Subject: Addendum No. 3 to Request for Proposal – Emergency Alert Notification System (“Crash Phone”)

Cleveland Hopkins International Airport
EMERGENCY ALERT NOTIFICATION SYSTEM ("CRASH PHONE")

**Burke Lakefront
Emergency Landing
Intercom**

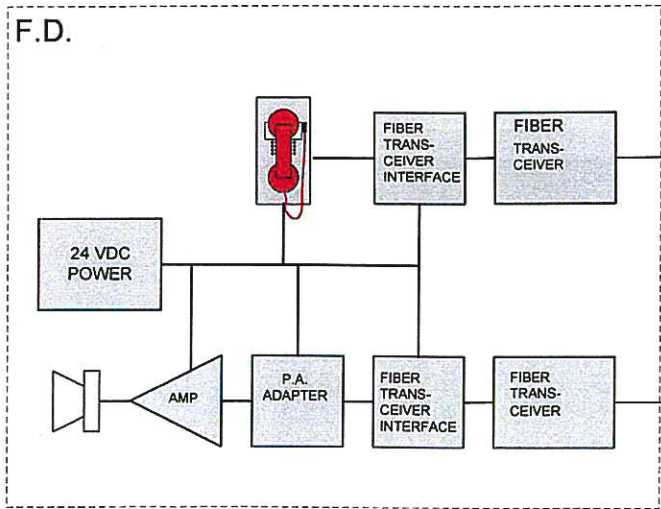
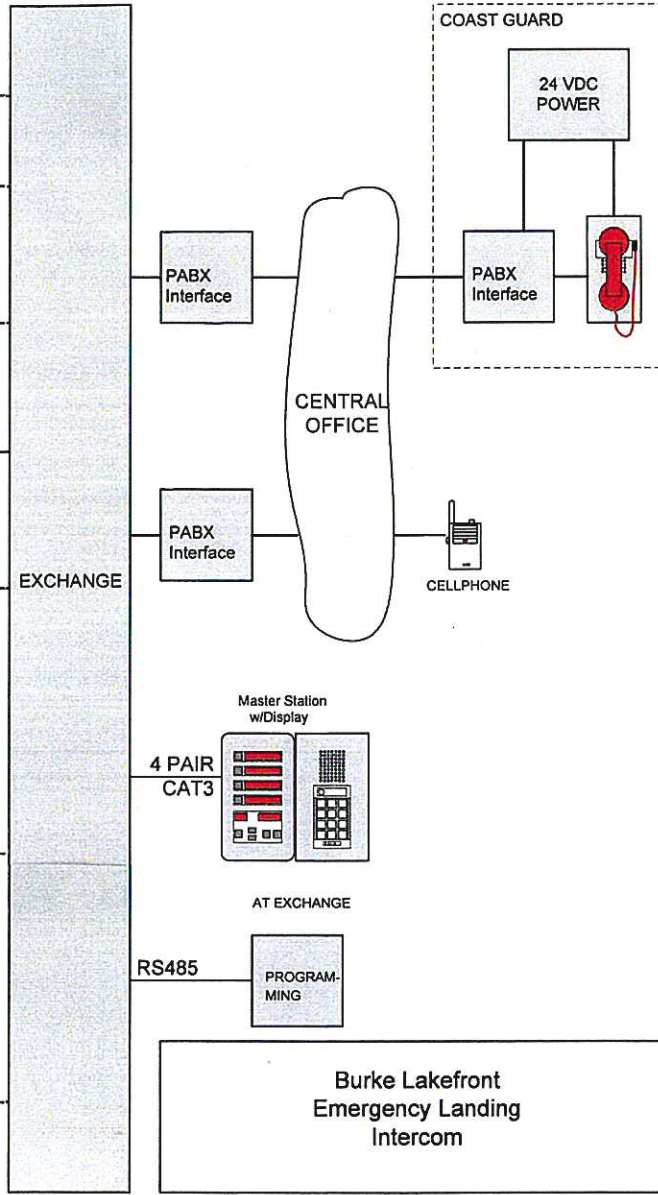
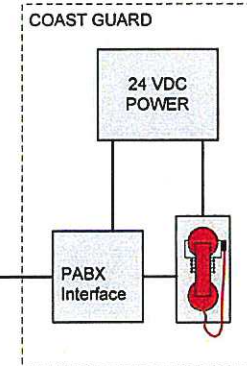
- Yes speakers or horns are required at each ARFF location and must be included in the proposal.
14. Exhibit G shows cell phone and security as telephone endpoints at BKL. Are these also required for the new system? Do they need full duplex capability or just "listen in" capability?

42. On the pre-bid conference call, one of your team took an action to provide a Diagram for the BLK as per the description in the RFP Document.
- Exhibit “G” - Diagrams for CLE & BLK**

- While there is a diagram for CLE, I don't believe your team have published one for BLK. And I don't see this explained in any of the Addendums.
- See Exhibit “G”

- The Police and Security telephone endpoints should be discarded for BKL. The cellphone endpoint is utilized by the City's Emergency Central Office. It should have full duplex. Additionally, the telephone endpoint at the USCG should only have "listen in" capability.

POLICE and SECURITY endpoints are not required at BKL
